To: Development Permit Panel

File: DP 11-593871

Re: **Application by IBI Architects (Canada) Inc. on behalf of South Coast British Columbia Transportation Authority (TransLink) for a Development Permit at 6302 No. 3 Road and 6411 Buswell Street**

DP 11-593871– BRIGHOUSE BUS MALL

ACOUSTIC SCREEN

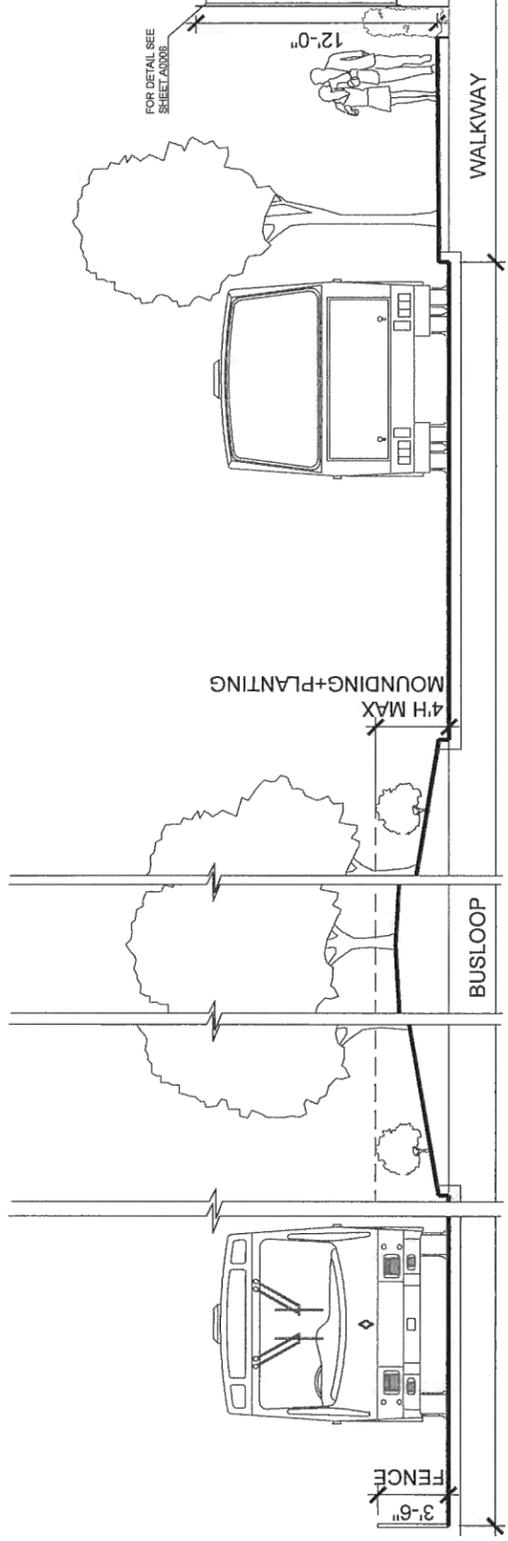
- review the design and material of the acoustic screen adjacent to the residential tower on the north of the Bus Mall to ensure that headlight glares coming from the bus loop will not go through to the western side of the existing building; and

The height of concrete wall has been increased to address the headlight glare. More dense/opaque patterns have been added at the bottom of the glass screen. The evergreen hedge has been removed.
